Application by Equinor for an Order Granting Development Consent for the Sheringham and Dudgeon Extension Projects.

Examination Timetable – Deadline 5

Examining Authority's Written Questions 3

Figure 1: Safe sea room assessment

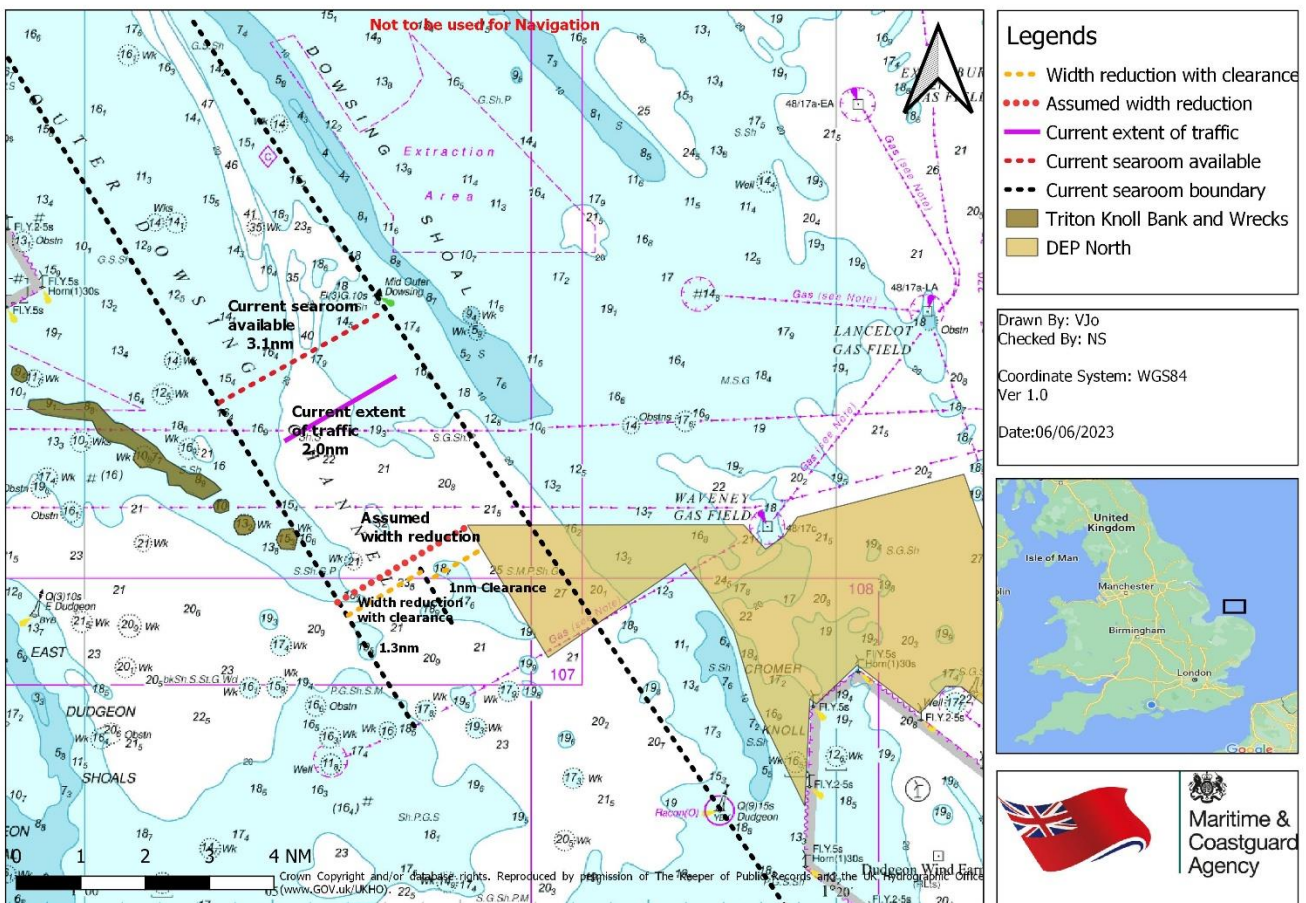
b) Provide your version of the Applicant's Figure 7.2 of the submitted Navigational Safety Technical Note [REP3-031], showing anticipated remaining sea room for ships, including safety buffers necessary.

The image below (Figure 1) shows our assessment of the anticipated safe sea room for vessels west of DEP North which includes a 1NM clearance from the boundary:

MCA's assessment is that the prevailing traffic will also choose to avoid the 15.3m and 13.2m wrecks (controlling depths) southeast of the Triton Knoll Bank. Therefore, the western extent of safe navigable sea space is based on this controlling depth and not the 10m contour line, as shown in Figure 7.2 of the applicant's Navigational Technical Note. This is evidenced in Figure 7.2 which shows all the transits except one, passed east of the 15.3m wreck. Our assessment is that 10m water depth does not provide sufficient depths for vessels with larger draughts in heavier or adverse weather where deeper water is required to accommodate dynamic draught, nor does it allow for the controlling depths as described above.

MCA raised concerns at Deadline 1 in our Written Representation that the area already has high collision risk which would only increase when navigating west of the DEP North array. When a safety buffer of 1NM is applied to the DEP North boundary, our assessment is that vessels will be constricted into a channel 1.3NM wide. This is a reduction of 58% from the current navigable sea room. It should be noted that this only applies to the operational phase. During the construction phase construction buoys will be deployed and the available sea room will be less than 1.3NM. An estimation of the sea room in this instance will not be possible until the positions of the construction buoys are known.

Figure 2: Recommended boundary amendment

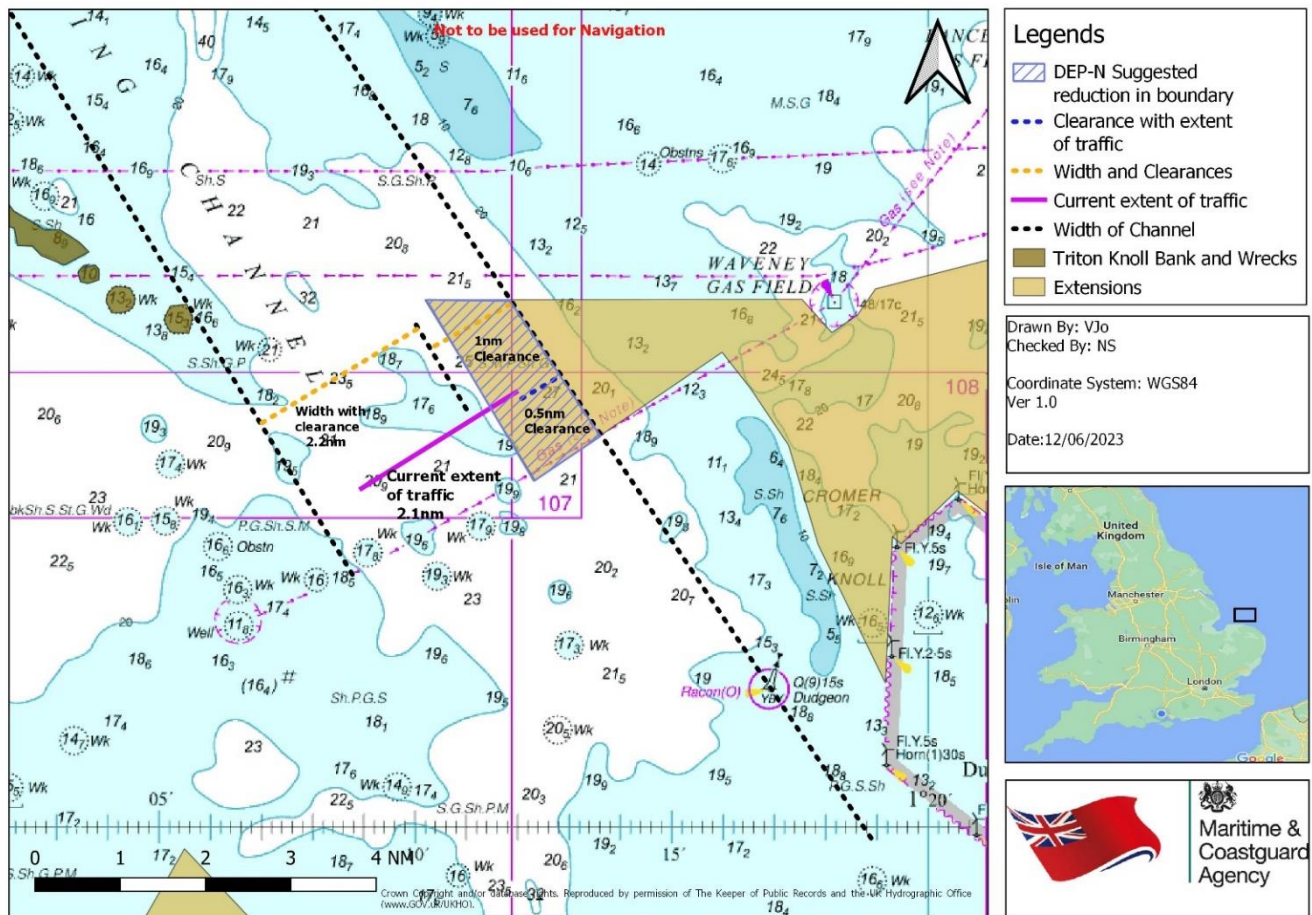
Details of Obstacle/Turbine Free Areas: *If the MCA considers that the only solution to address the concern about navigational safety to the west of the proposed DEP-N windfarm site is to have a turbine/obstacle free area, can this be clearly shown on a map/chart of the area within the DEP-N boundary that this would need to relate to.*

The image below (Figure 2) shows a line running through the Mid-Outer Dowsing buoy and Dudgeon buoy and MCA recommends the boundary is reduced to this line, as a minimum:

There would still be a reduction of safe navigable sea room to the current availability when safety clearances are implemented. Figure 2 shows the current extent of traffic (magenta line), and the distance between this shipping route and the amended turbine boundary would be 0.5NM which is the minimum recommended distance in MCA guidance MGN654 Annex 2 'Wind Farm Shipping Route Template'. This reduced boundary would increase the safe navigable sea room to 2.2NM when a 1NM clearance distance is applied.

The current extension at the northern section of DEP North as previously highlighted, poses an unacceptable risk to navigation due the reduction of safe and available navigable sea room in an already constricted area. As this area has pre-existing navigational constraints and is a commercially important route, any intentional introduction of hazards (turbines) that cannot be safely mitigated, will not be supported by the MCA. The implication is that MCA recommends that consent should not be granted for the current proposed boundary of the northern section of DEP North. Instead, the MCA recommends a reduction to the red line boundary to a line between the Mid-Outer Dowsing buoy and the Dudgeon buoy as per Figure 2 above.
